ADDENDUM NO. 6

Project Name: Indian River County Fire Station 7 (IRC-1911)

Bid Number: 2024041

LANDSCAPE PLAN

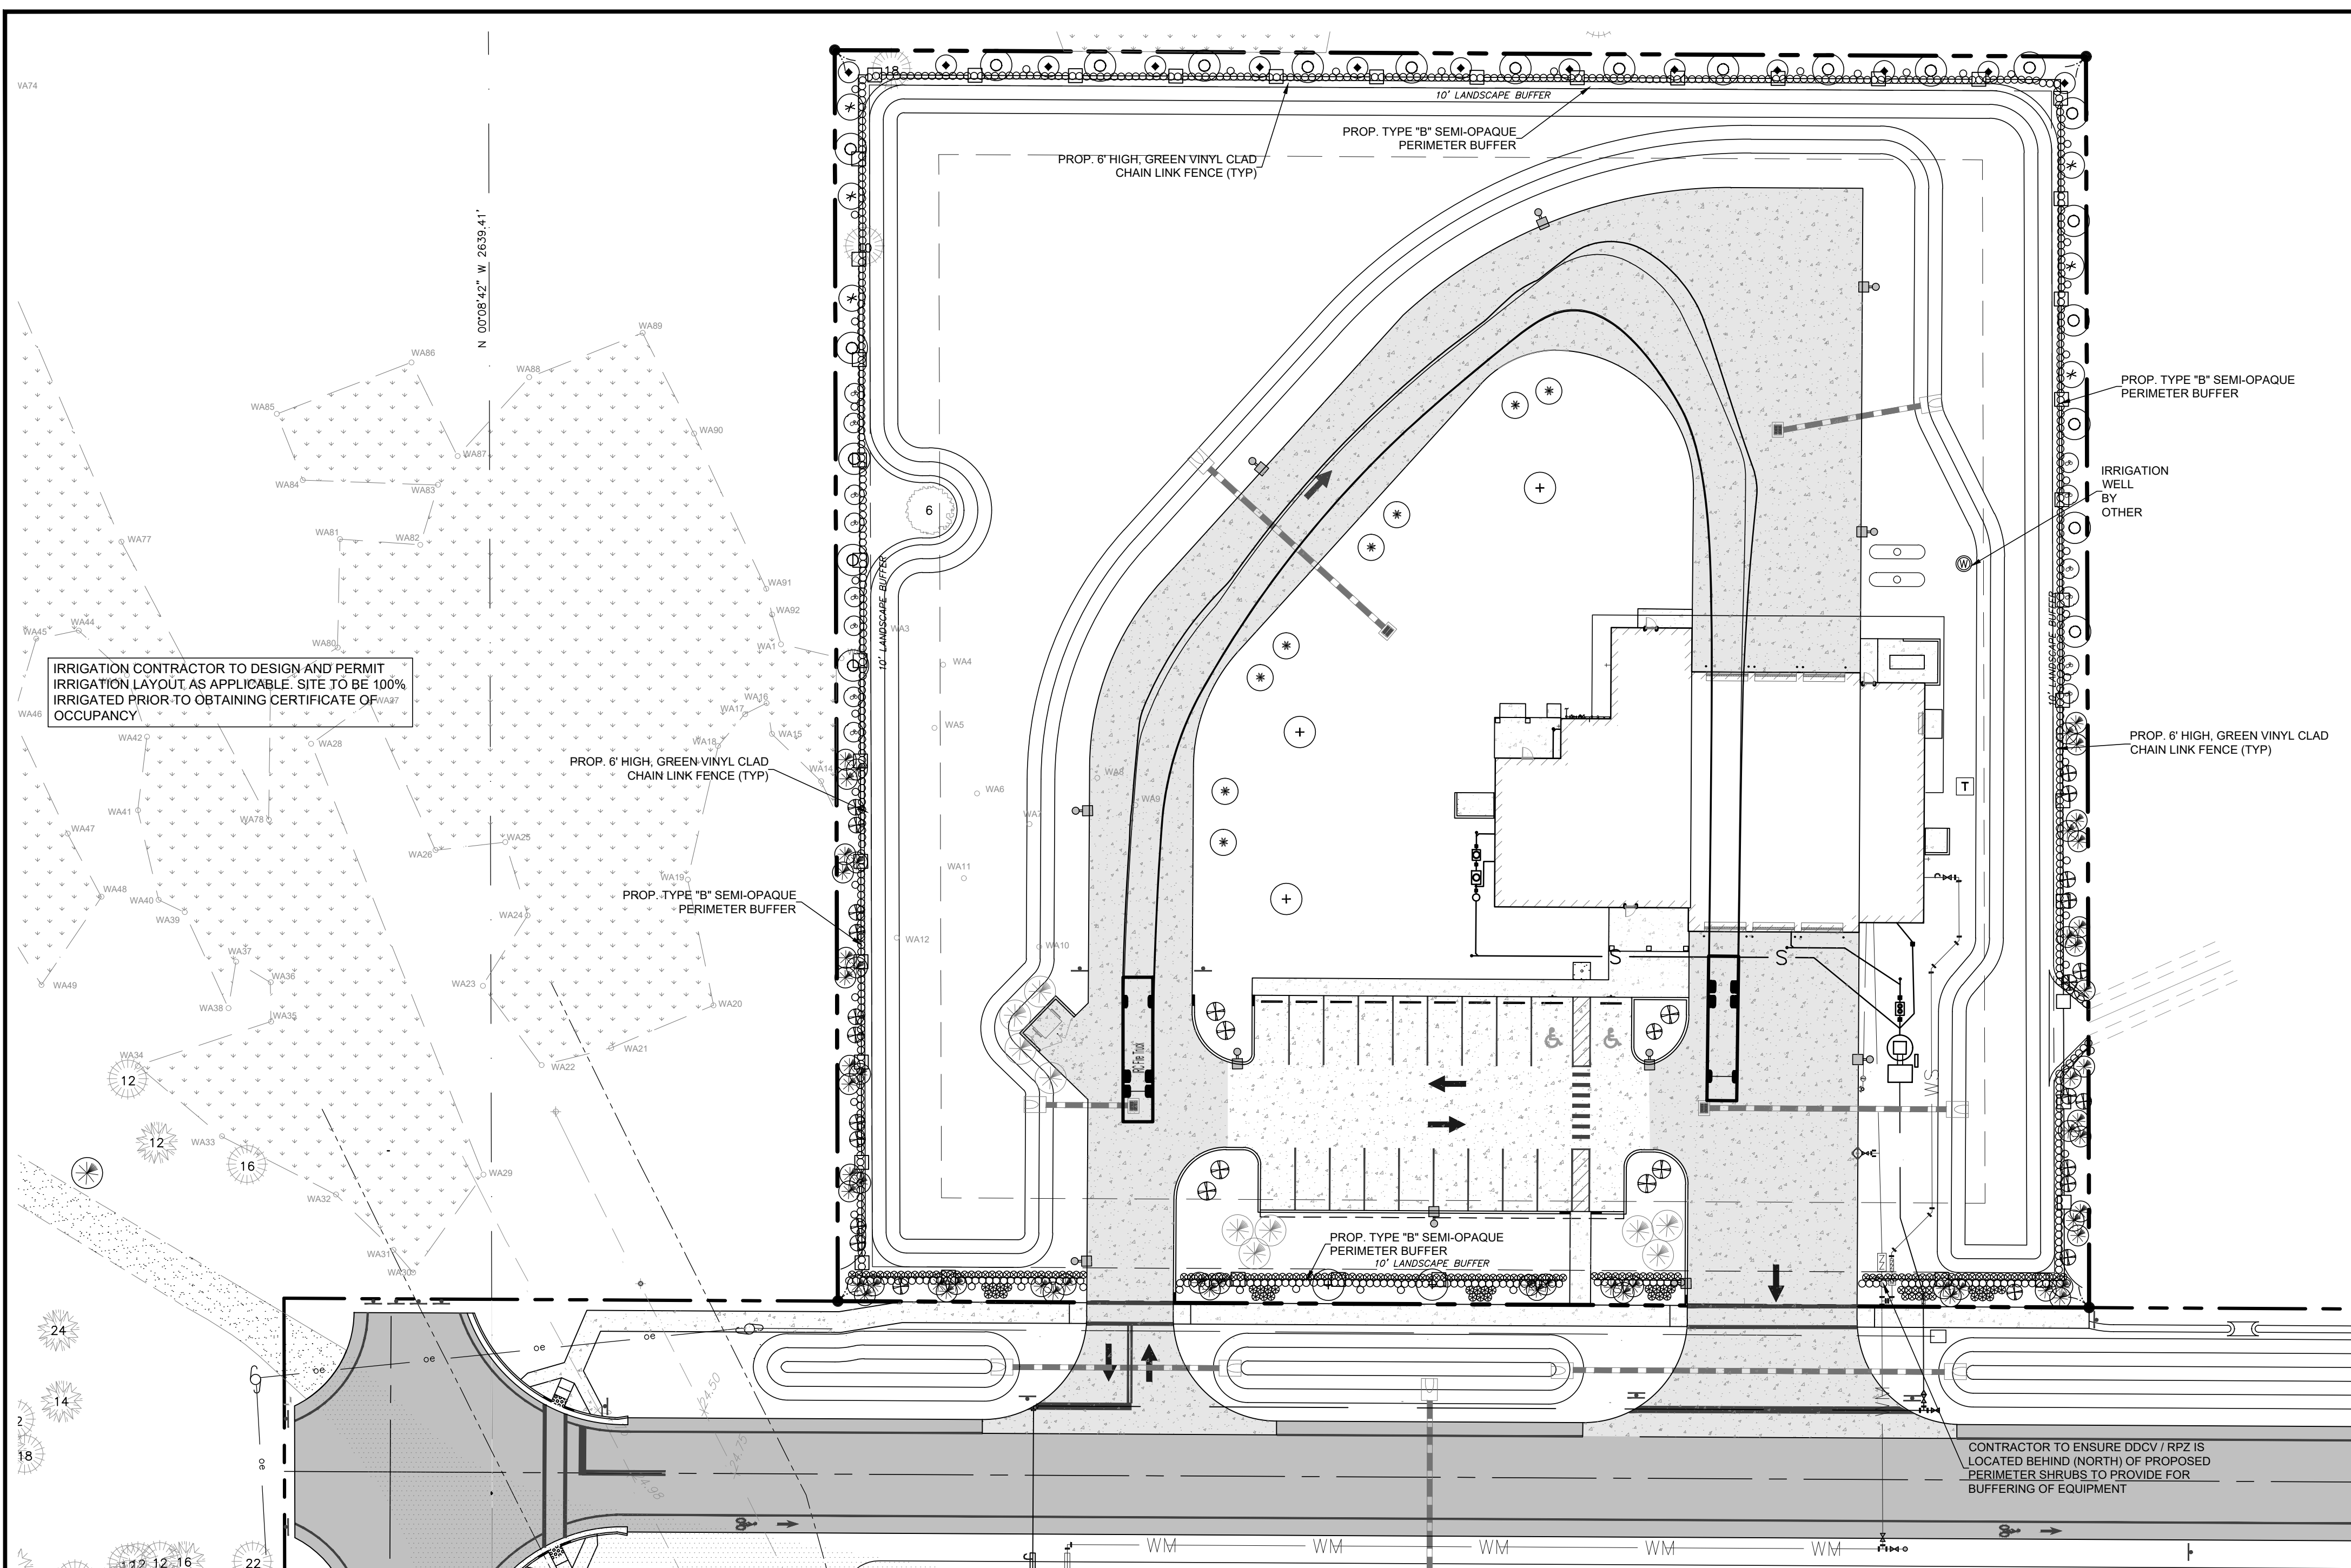
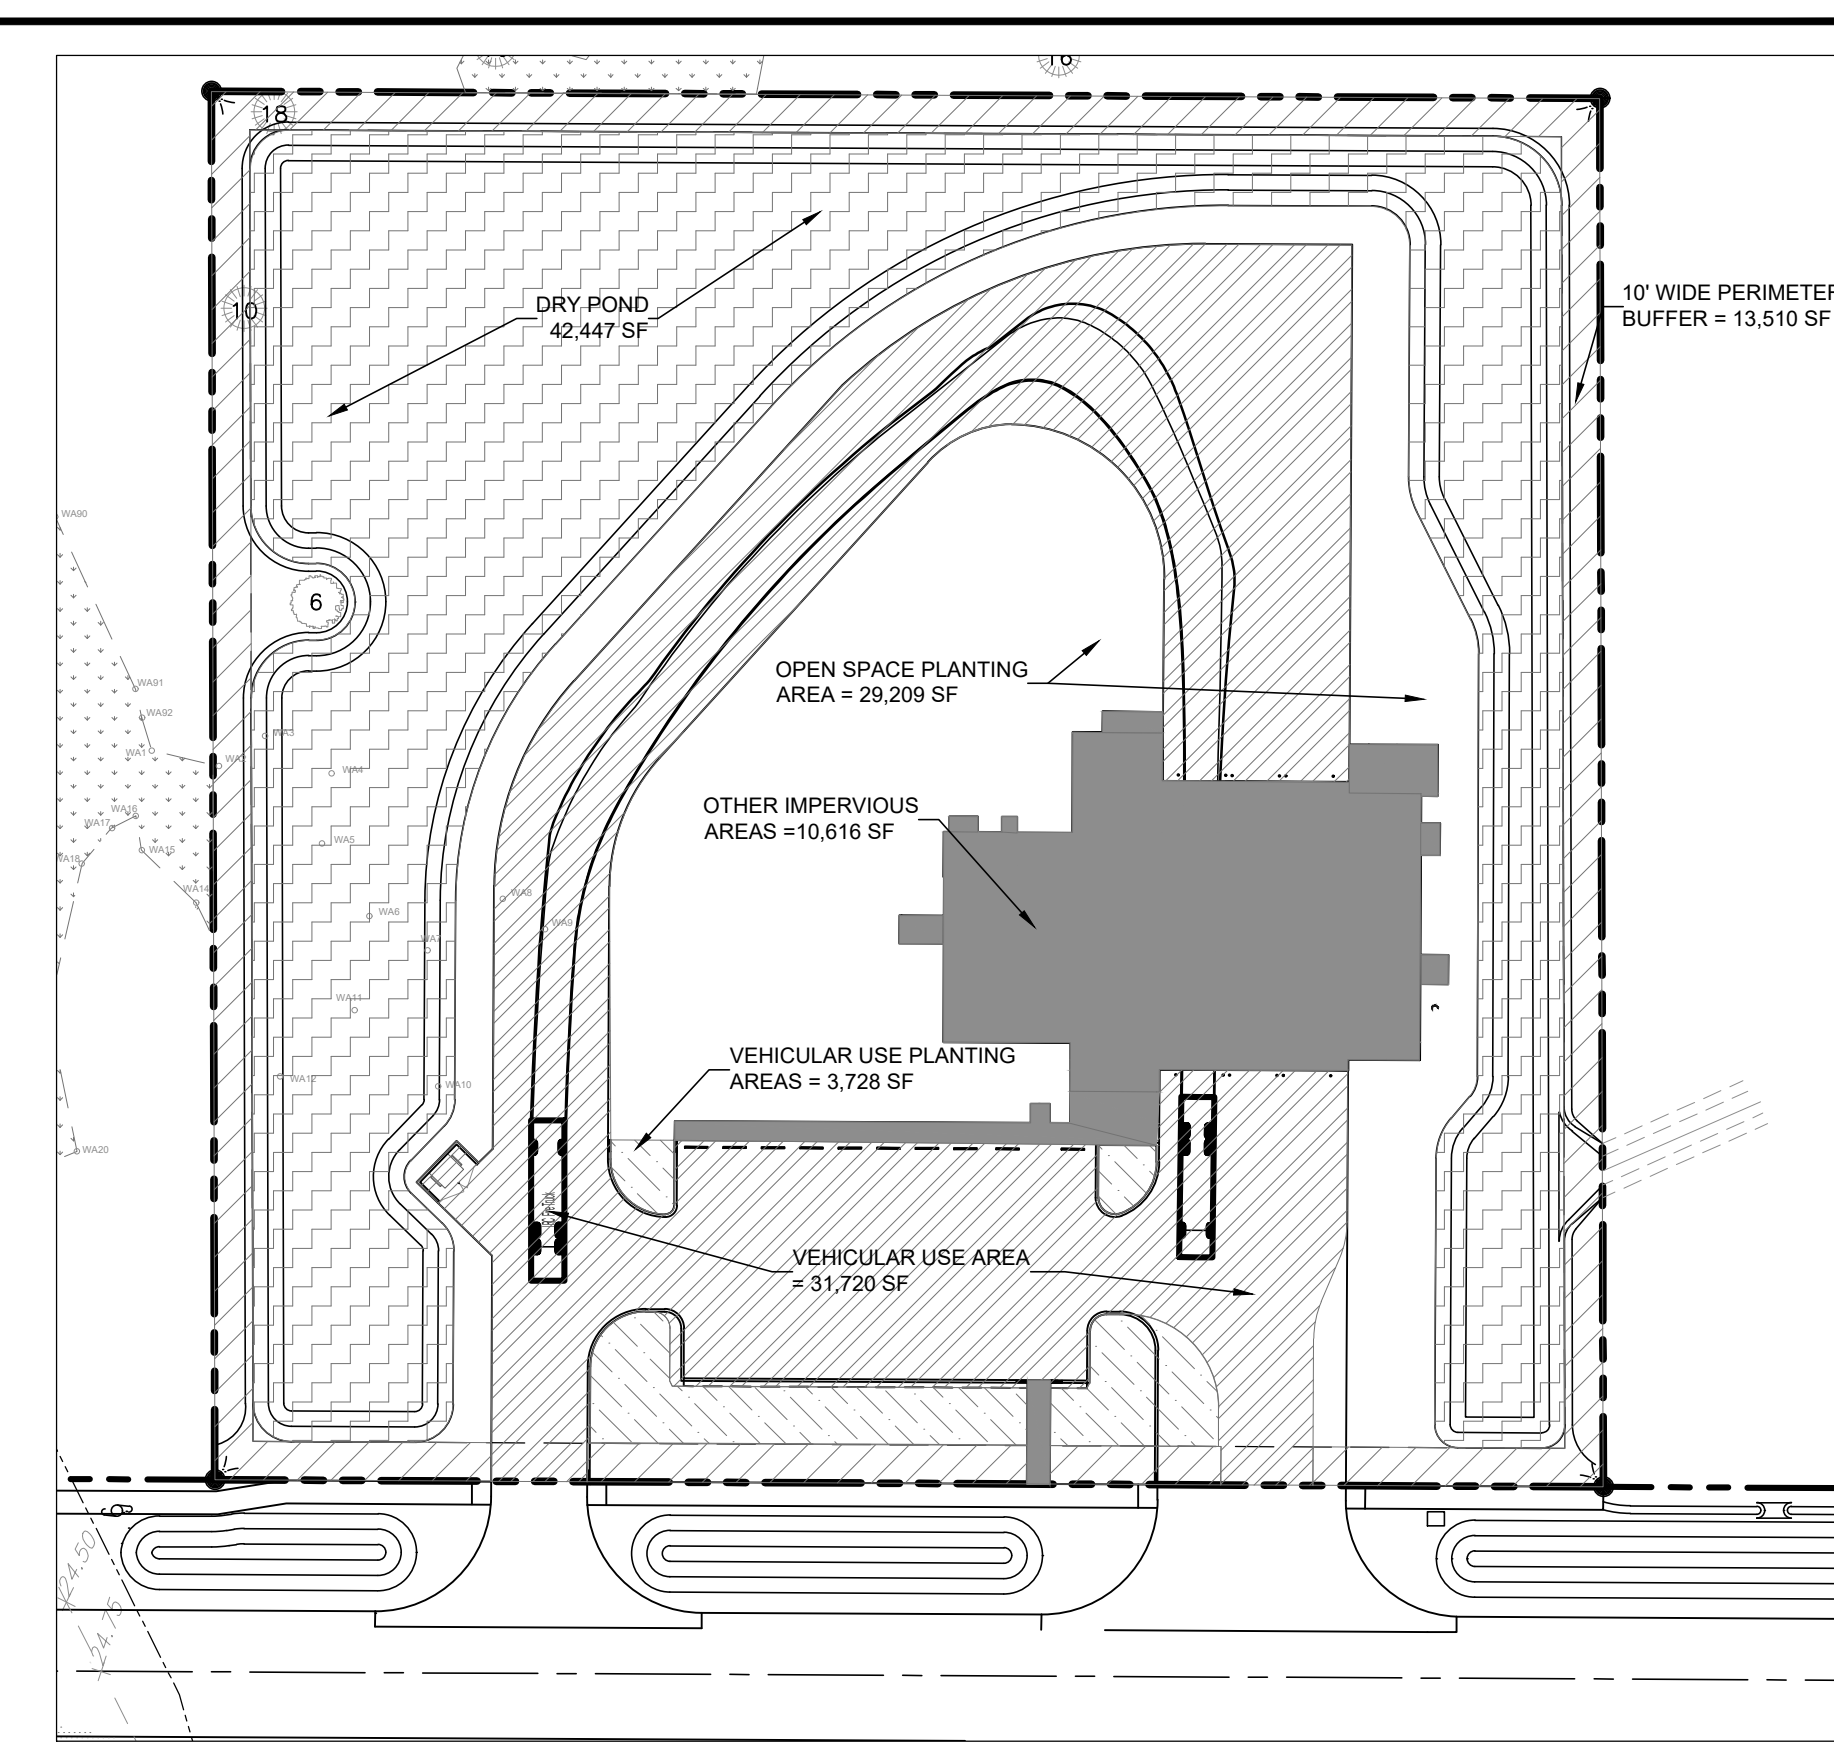
14. Schedule Shows '315' Number of Crape Myrtle. But We Found Only '31'. Please Verify
The Correct number for Cape Myrtle is 31. The 315 in the schedule is a misprint

15. Schedule Shows '684' Number of Dwarf Schefflera. But We Found Only '640'. Please Verify
The correct number of Dwarf Schefflera is 684. Plan view has been revised to match.

16. Schedule Shows '36' Number of Pampas Grass. But We Found '46'. Please Verify
The correct number of Pampas Grass is 36. Plan view has been revised to match.
